OWNER:	TELANGANA STATE POWER GENERATION CORPORATION LTD. HYDERABAD - TELANGANA, INDIA			
CONSULTANT:	DESEIN PRIVATE LIMITED			
PROJECT:	BHADRADRI THERMAL POWER STATION 4 x 270 MW, UNITS-1 TO 4, MANUGURU, TELANGANA, INDIA			
EPC CONTRACTOR:	BHARAT HEAVY ELECTRICALS LIMITED INDUSTRIAL SYSTEMS GROUP ISG-BANGALORE			
TITLE:	G.A OF TP-3 WITH LOAD DATA			
SCALE:	BHEL JOB NO. IS-1-14-2007			
	BHEL-ISG IS-1-GA-691-104-M021 DRG.NO.:			
				REV. 01

COMPLIANCE TO COMMENTS OF DESEIN

ON GA DRAWINGS OF TP-3 R0 SUBMITTED BY BHEL FOR APPROVAL

Ref:	Comments made on GA Drawing prints of TP-3, IS-1-GA-691-104-M021, R0 by DESEIN		
SL NO	DESEIN COMMENTS.	COMPLIANCE / CLARIFICATIONS BY BHEL	REMARKS
	COMMENTS MARKED MEMO		
1	Monorail shall be projected 3 m from the out side sheeting of the transfer tower. Please correct.	Noted & revised.	
2	Please indicate the down comer and tramp iron chute clearance from the ground level.	Indicated	
3	Please include details of 1 ton hook provided at various places in the hoist schedule.	In hoist schedule, only details of hoist will be indicated. However, capacity & location is indicated in resp plan & elevation view & same shall be taken care by our civil in drgs.

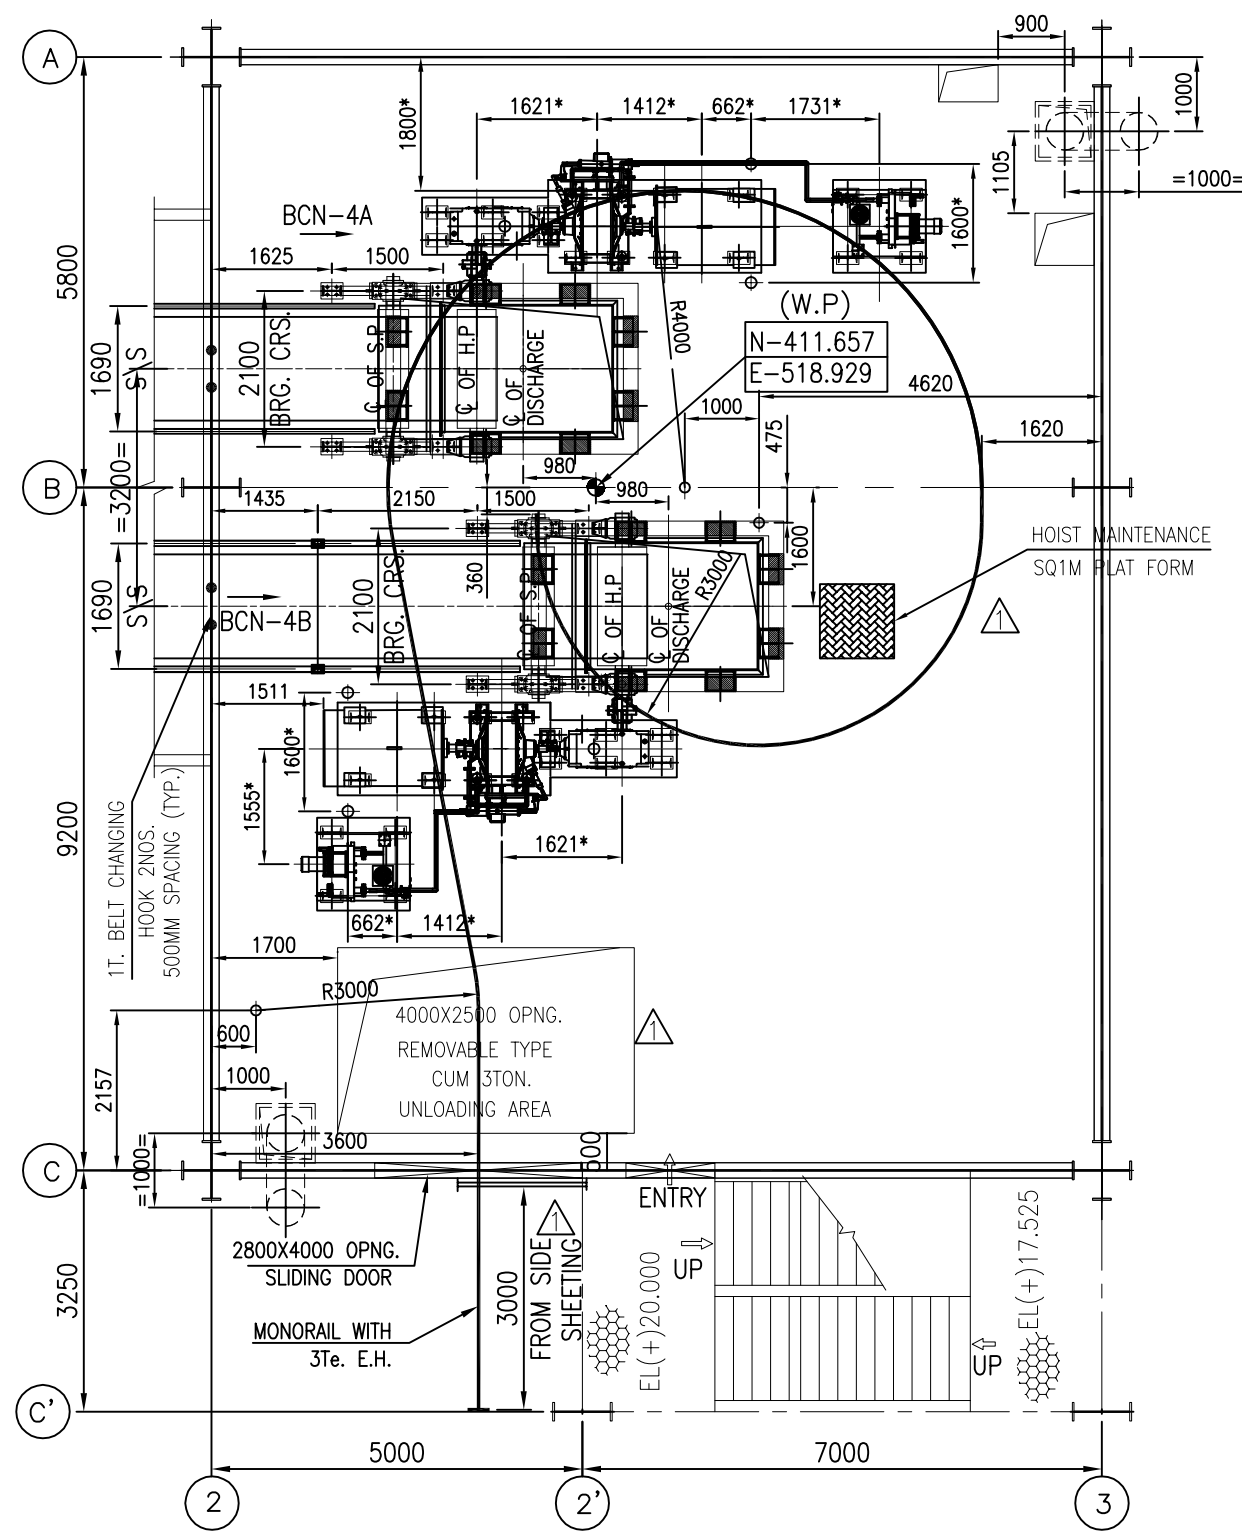
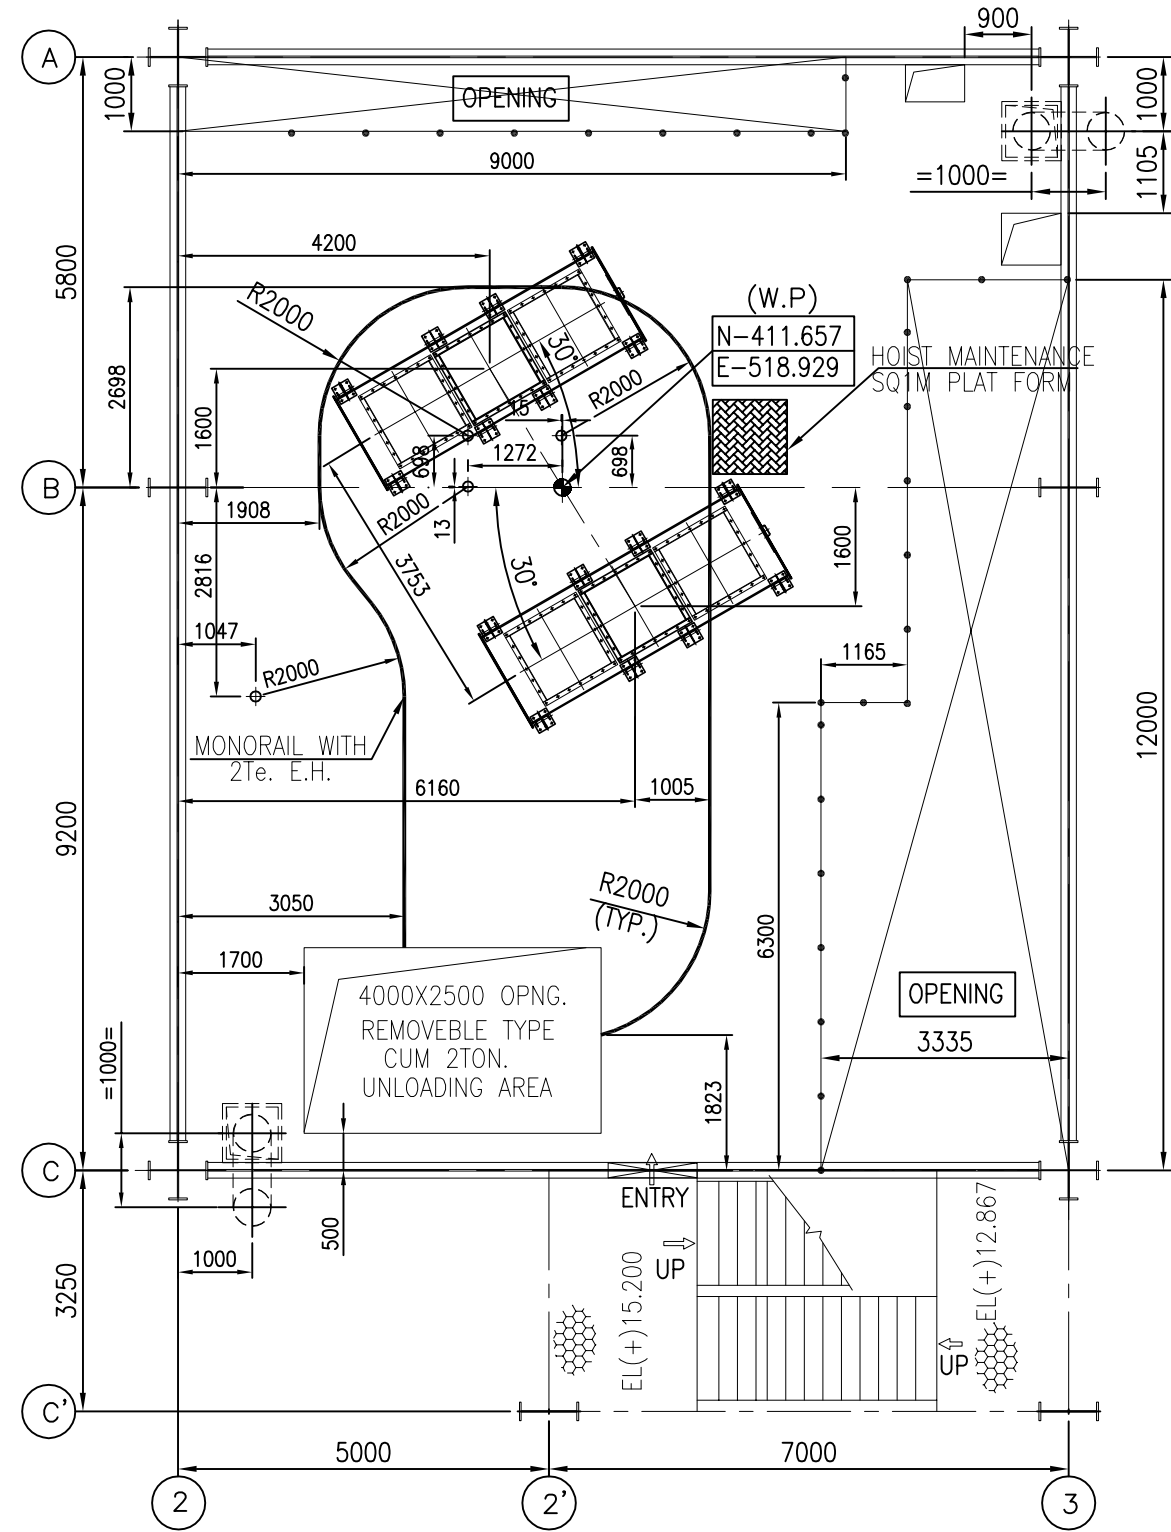
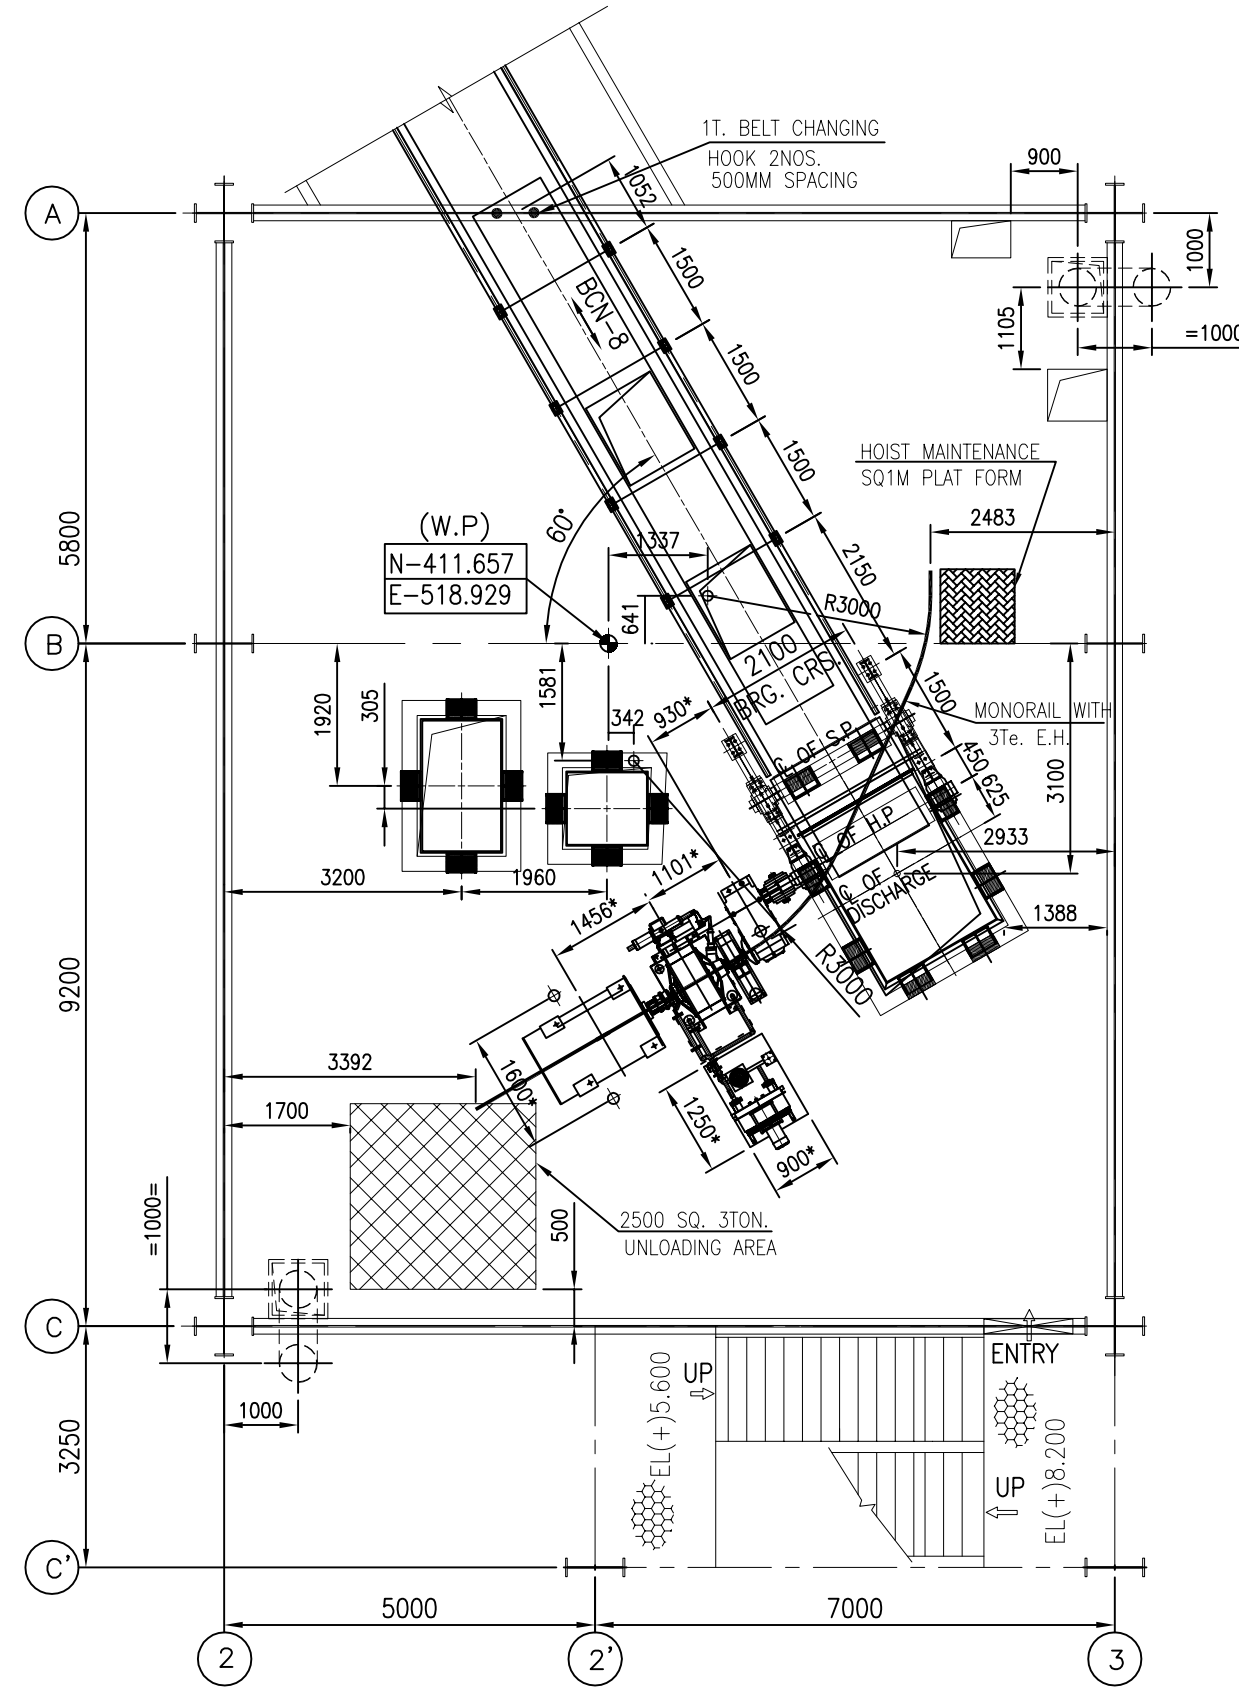
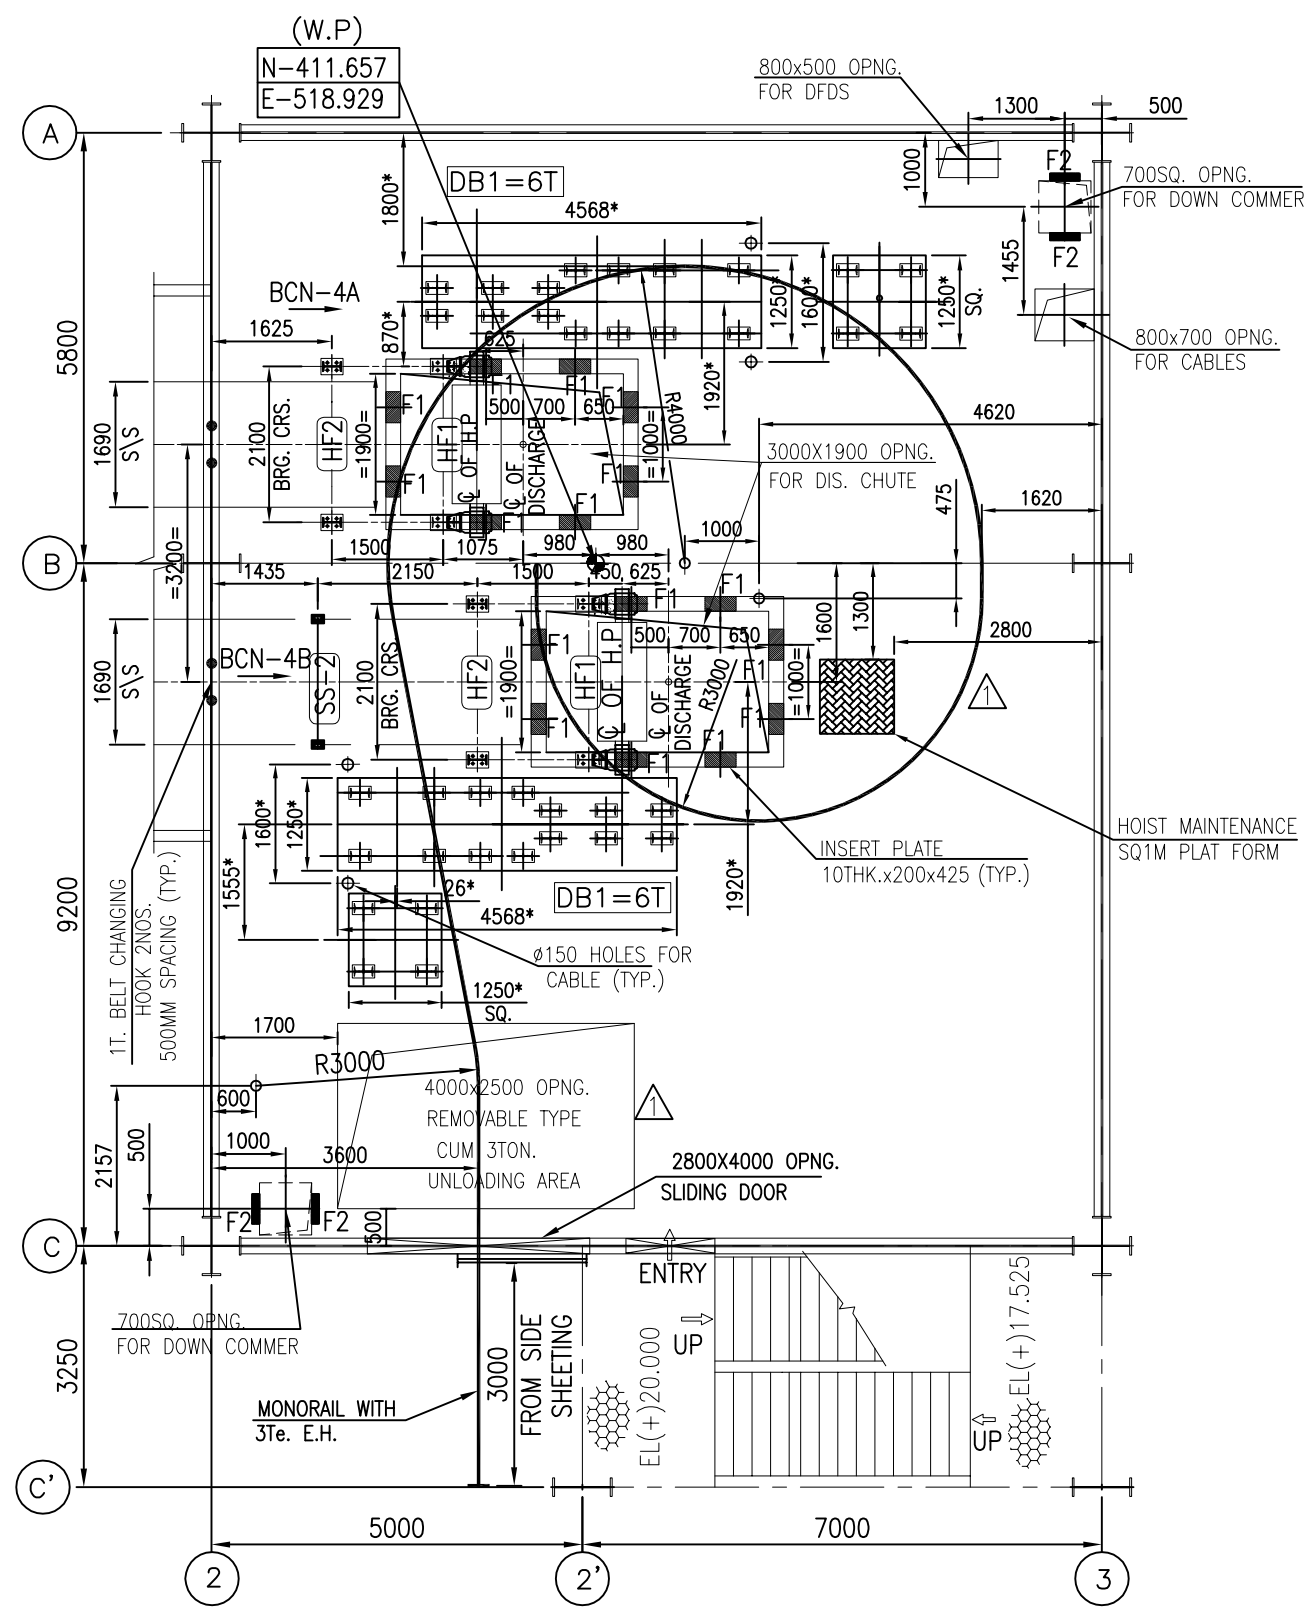
1	20-10-15	REVISED AS PER DESEN COMMENTS DATED 18-7-15	J.S.	M.K.N
R.No:	DATE	BRIEF RECORD	BY	APPD
REVISIONS

- △ 8. FOR DS/SW/DW SYSTEM, SEPARATE DETAILED DRGS. WILL BE FURNISHED AT LATER STAGE.
9. CIVIL REQUIREMENT INDICATED TENTATIVE.
- △ 10. CURB WALL BE PROVIDED AROUND ALL OPENINGS.
